ADVISORY
 BULLETIN

No. 2000-05

Manual Tilt Cross Pin Loose – 55/60 (2-Stroke)

2000 55/60 (2 Stroke)

51147

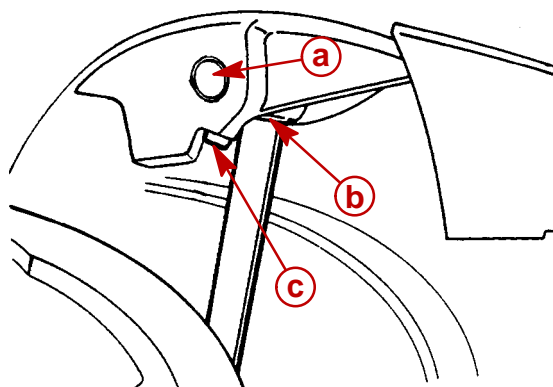
55 and 60 hp three cylinder two stroke outboards within the serial number range listed in this advisory may have an upper manual tilt cross pin that is not properly held in place. The locking tri-lobe pin hole may be drilled off location and has not positioned the locking pin properly in the groove of the cross pin.

If a loose upper manual tilt cross pin moves out of location towards the port side, the pin end may eventually interfere with the port clamp bracket and hinder tilting of the outboard. If the cross pin moves to the starboard side, it could disconnect from the manual tilt rod end and not provide the tilt assist feature as designed.

Inspect every outboard listed in this document for a loose manual tilt upper cross pin. If the pin is loose and not retained by the locking tri-lobe pin, install a newly designed Swivel Bracket Pin Assembly P/N 17-878592A1. The pin assembly contains a new design upper cross pin, washers, and snap rings.

Swivel Bracket Pin Assembly 17-878592A1 Installed

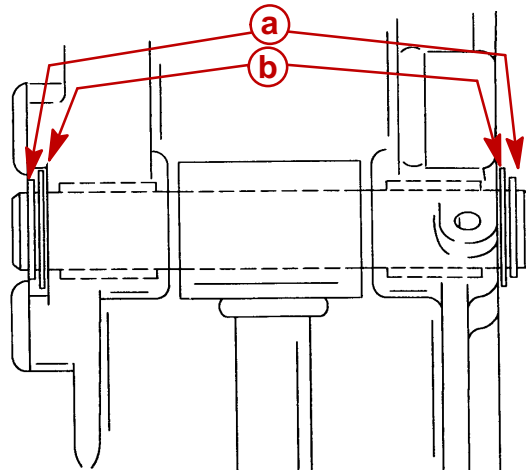
If the manual tilt pin can be moved out of position. Remove and discard the locking tri-lobe pin and manual tilt pin. Install the Swivel Bracket Pin Assembly 17-878592A1.

This new Swivel Bracket Pin Assembly 17-878592A1 only replaces the standard 17-19607 cross pin in instances when the locking tri-lobe pin hole is drilled off location.
